## SERVICE BULLETIN

**APPLICABILITY:** 2012MY Impreza

**NUMBER:** 12-148-13

**SUBJECT:** “Rattle” or “Popping” Sound From Rear Door Area

View is from above the vehicle, looking down into the L/R door jamb / floor area.

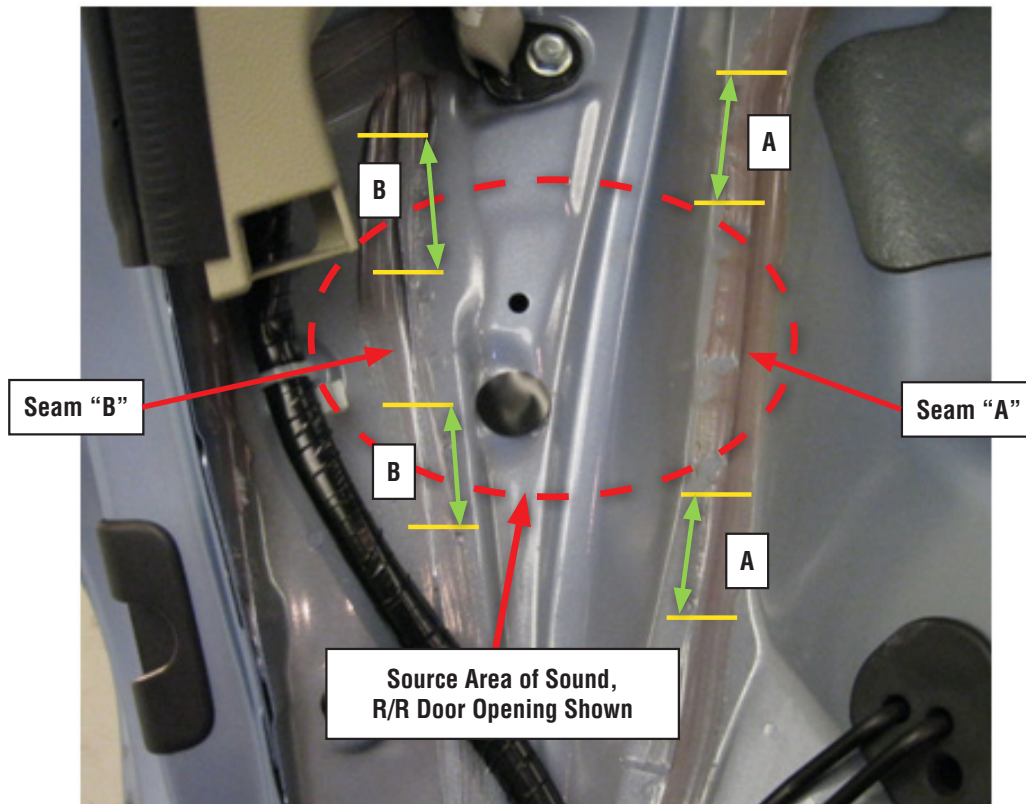
This bulletin provides a repair procedure to address a customer concern of a “rattle” or “popping” sound which could come from either of the rear door opening areas. The sound may occur over small bumps or when a twisting motion is introduced into the vehicle body at low speeds. The cause is an insufficient gap between multiple layers of the body structure where they are spot-welded together as shown in the illustrations below.

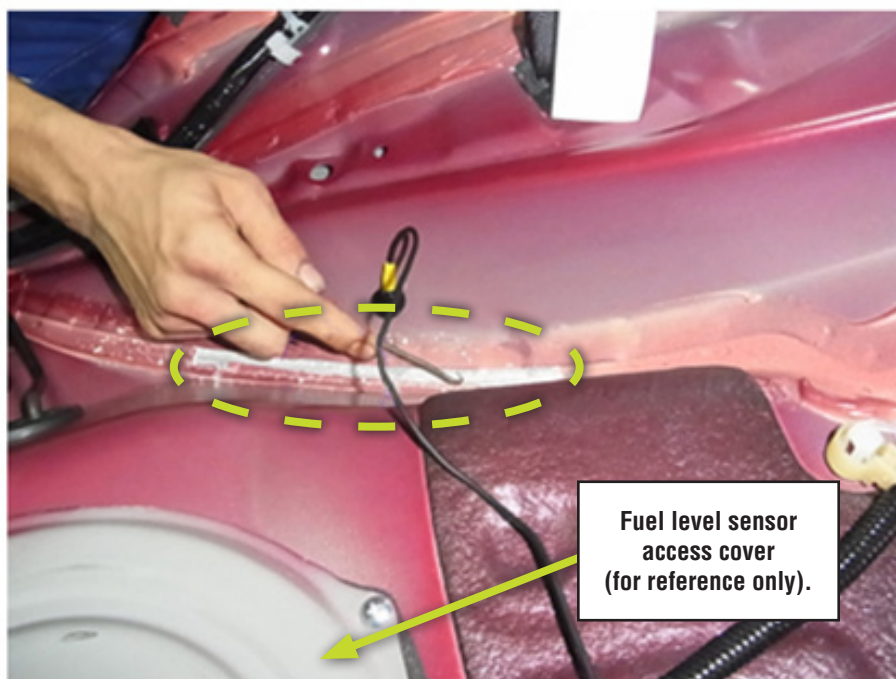
1. Remove the rear seat cushion and the door sill trim panel to access the affected area shown below following the procedures outlined in the applicable Service Manual. Once the seat cushion and trim are removed, road test the vehicle again to confirm the area circled in the photo below is the source of the sound.

2. Remove the sealer from the seam "A" areas shown in the photo above using a scraper.
3. Next, using a pick tool as shown in the photo below, remove the sealer from between the layers of sheet metal.

4. Once the sealer has been removed, using a flat-blade screw driver, carefully work it in between the layers of sheet metal and increase the gap in the areas between the spot-welds in the two “A” sections shown on page 2 first. Only spread the layers enough to allow the spray grease to penetrate (Step 7).

5. Next, road test the vehicle again to confirm whether or not the sound has been eliminated.
6. If the sound persists, repeat Steps 2 - 5 on the “B” sections shown on page 2.
